Work Order ID 100964

Item Name: Crosstube Fwd High

DRAWING NO. D212-664-141	TITLE XTUBE ASSY (205/212/412 HI FWD)	REV. D	DART AEROSPACE LTD ENGINEERING ORDER		D.E.O. NO. D212-664-141-D-1	SHEET NO. SHEET 1 OF 2	SCALE NTS
DRAWN	CHECKED	UP	MFG. APPR.	APPROVED	DE APPR.		
DATE 11.04.07	DATE 11.07.11		DATE 11.04.12	DATE 11/04/12	DATE 11.04.12

ADD AN INSPECTION WINDOW TO UNDERSIDE OF CROSSTUBE.

**D212-664-141/-141B
ASSEMBLY DETAIL**

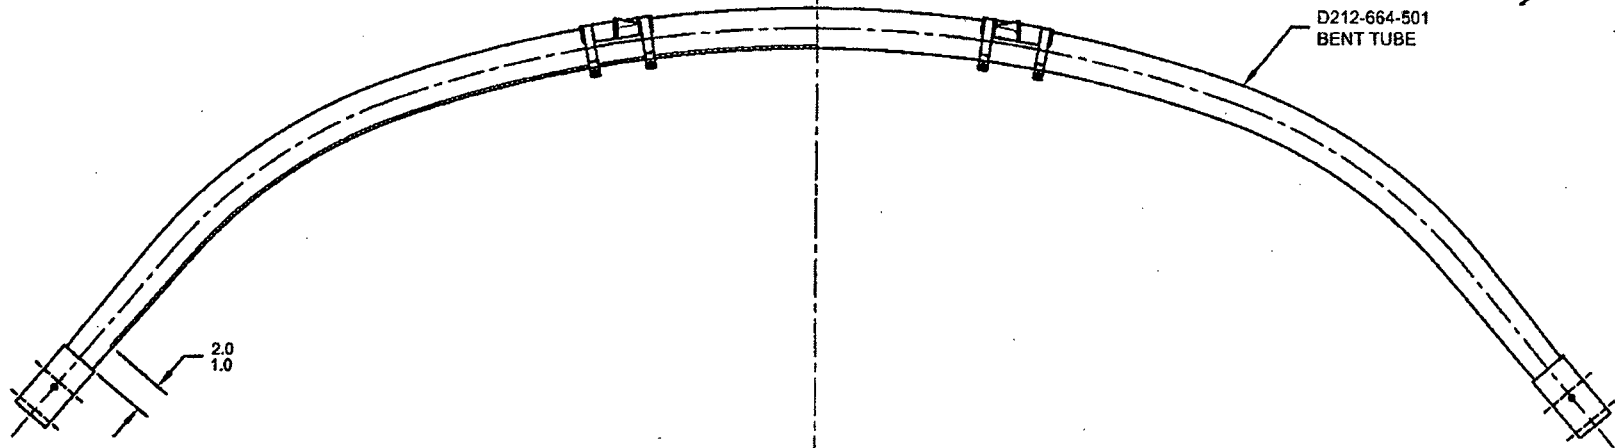
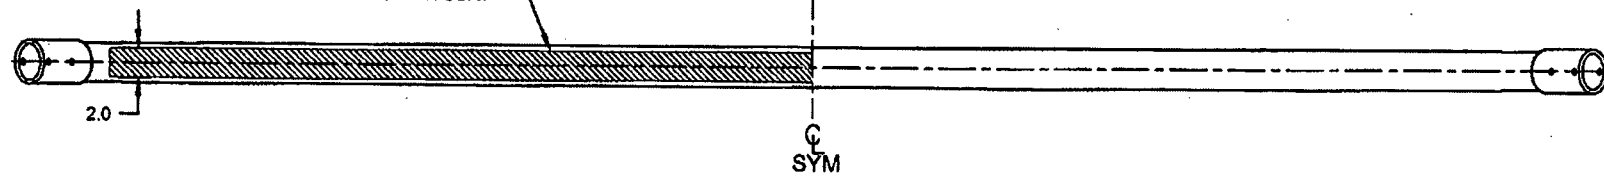
NOTES 2 OF SHEET 1 IS AMENDED AS FOLLOWS:

- 2) FINISH: CHEMICAL CONVERSION COAT PER DART QSI 005 4.1
PRIME INSIDE AND OUTSIDE PER DART QSI 005 4.2
MASK UNDERSIDE OF CROSSTUBE AS SHOWN (HATCHED AREA) AND
PAINT OUTSIDE PER DART QSI 005 4.2
REMOVE MASKING AND APPLY CLEAR COAT

- 2) FINISH: CHEMICAL CONVERSION COAT PER DART QSI 005 4.1
PRIME INSIDE AND OUTSIDE PER DART QSI 005 4.2
PAINT OUTSIDE PER DART QSI 005 4.2

MASK AREA PRIOR TO PAINTING,
REMOVE MASKING AFTER PAINT
AND APPLY CLEAR COAT
